## SERVICE ACTION

<b>Reference number:</b>	SA-01-1546	<b>Issued:</b> 31 August, 2021
<b>Subject:</b>	Install New Screws for the Front Splitter	
<b>Model(s):</b>	Vantage F1 Edition	
<b>VIN Range:</b>	Refer to the separately published list of affected Vehicle Identification Numbers (VINs)	
<b>Applicable to:</b>	All Dealers	
<b>Distribute to:</b>	After Sales Manager Executive Manager Service Manager Sales Manager	Warranty Staff Technician(s) Parts Staff

Figure 1

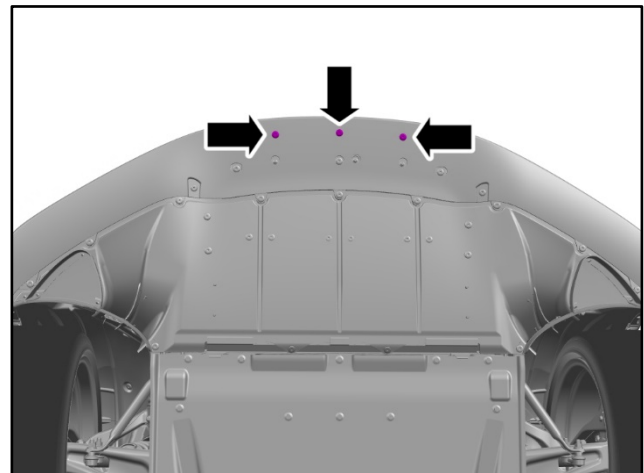
Aston Martin has identified some Vantage F1 edition vehicles that may not have the correct front splitter screws installed. To correct this problem, do the workshop procedure that follows.

1. Lift the vehicle and make it safe.
2. Remove the incorrect screws for the front splitter (refer to Figure 1).  
If the screws for the front splitter are not installed go to step 3.

3. Install the correct screws to the front splitter.
4. Lower the vehicle.

Description	Part Number	Quantity
SCREW M6X19 TORX HD	6G33-FA0115-AB-PK	1
